MINUTES OF THE MEETING March 20, 2008

Seattle Design Commission

Urban Mobility Plan
Fire Station 35 – Crown Hill
Fire Station 30 – Mount Baker
Councilmember Richard Conlin
Capitol Hill Station ST University Link

Figure 7: Art piece

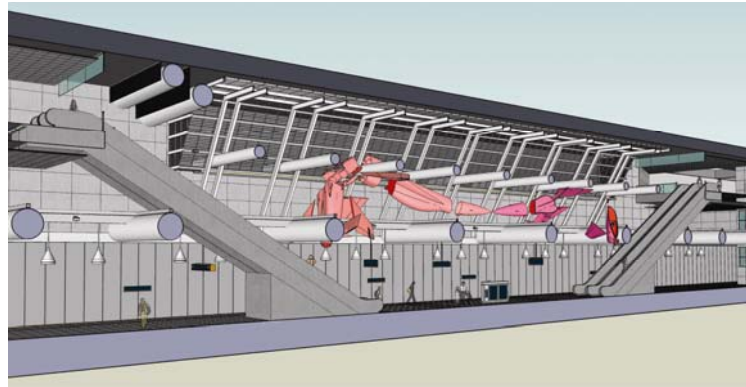
- The materials palette seems reserved and somewhat institutional and may benefit from a more dynamic color scheme.
- Some panel members expressed a concern for the use of warplanes in art piece in the context of a light rail station. While we appreciate the artist's intention of expressing fluid movement and natural forms, the relationship between natural form and a fighter plane as presented is questionable. A solution may be an artist statement prepared for the next presentation to clarify the appropriateness of the art in the station.

- Other ways planes penetrate architecture that is not so offensive?
 - Urge great care in emphasizing poetry of forms in people's minds. Notion of destruction is there in the fighter jets, but the entire form after deconstruction of the pieces is holistic. The piece is not meant to convey aggression.

- Chosen a provocative art piece. Planes may be appropriate with everything that is going on in area and the neighborhood.
- Concern over violent ramifications of art piece. Appreciate that the art seeks to connect important "Seattle qualities" of nature and technology into this piece, but question the use of a fighter jet as the manifestation of those ideas. Encourage further reflection on this, and preparation of an artist's statement for review next time.
